APPLICATION FOR CERTIFICATION For the PALMDALE HYBRID POWER PROJECT

Docket No. 08-AFC-9

ERRATA TO THE PRESIDING MEMBER'S PROPOSED DECISION

PROJECT DESCRIPTION - FIGURE 1

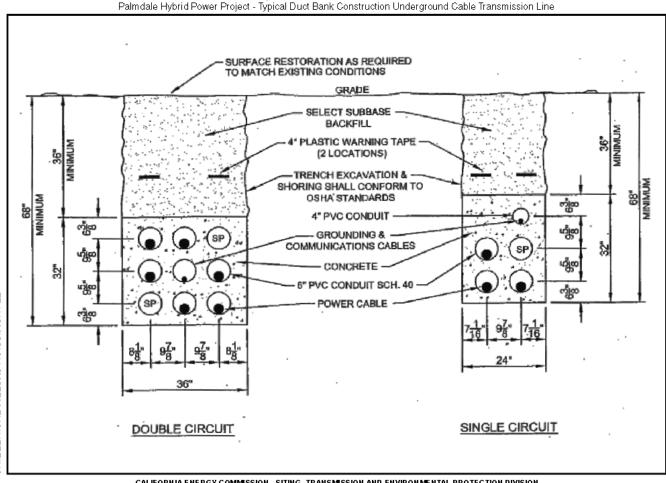
3. Page 5.4-4. Alternatives Appendix A – Figure 1 "Diagram of a Typical Transmission Riser Structure – Palmdale Hybrid Power Plant" should be replaced with Project Description – Figure 1 "Palmdale Hybrid Power Plant – Typical Duct Bank Construction Underground Cable Transmission Line."
